Delegated Report

Householder Planning Application

Planning Application No: 20220807

Location: 10 Windsor Road Gravesend Kent DA12 5BN

Existing Rear Elevation

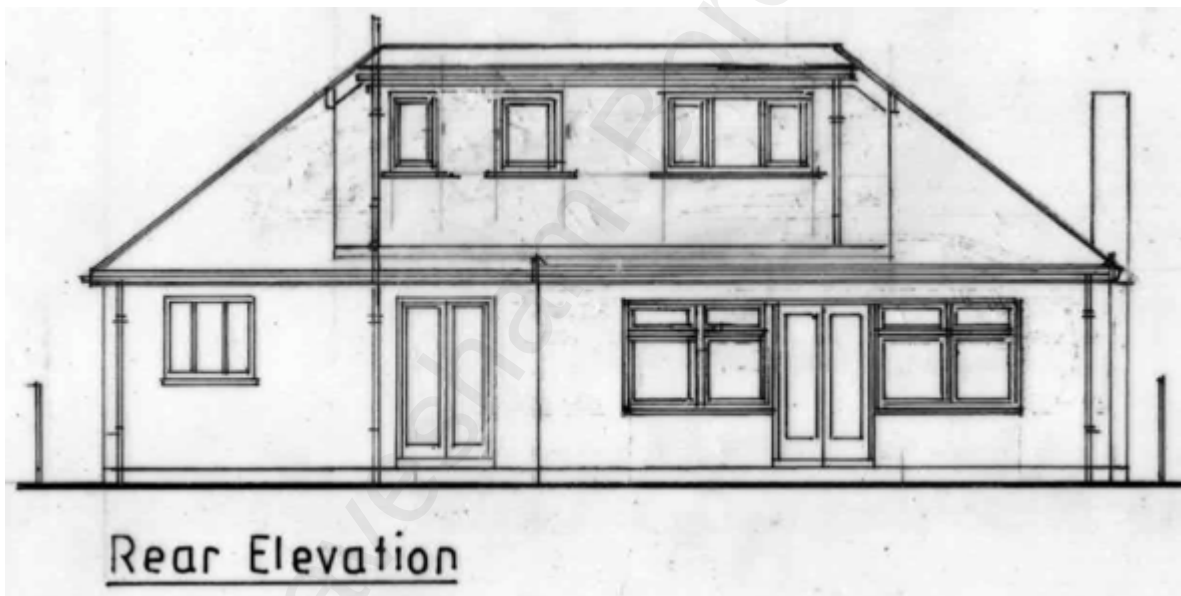
In this scheme the smaller dormer was to serve an en-suite and the enlarged dormer was to serve a bedroom.

The applicant no longer wishes to construct the individual dormers as permitted and now wishes to erect one large box dormer across the whole of the rear roof slope as follows:

The revised proposed rear dormer extension would be much wider, taller and deeper than the two permitted dormers. The below extract from the delegated report from ref. 20180670 states how the

This new proposed dormer would be so large that the top of its flat roof would be in line with the ridgeline of the host dwelling, it would only be set up a very minimal amount from the eaves line and both corners of its roof would be located right up to the side roof slopes of the dwelling and as a result would have truncated corners to the dormer. It would appear much less subordinate to the host property and a much more dominant and incongruous addition. All three windows in the dormer would be different sizes and proportions and not match or align with those in the ground floor rear elevation.

The proposed rear dormer extension would not comply with this advice. Instead it would be a large and bulky dormer which would be much wider, deeper and greater in height than the two approved dormers and would occupy a significantly larger proportion of the rear roof slope. Consequently it would dominate the rear roof slope to the detriment of the appearance of the dwelling overall. The rear dormer due to its scale would be partially visible from Windsor Road, and also from surrounding properties in Windsor Road and Singlewell Road to the rear where its bulk and massing would be apparent. It would also therefore have a harmful effect on the character of the area.
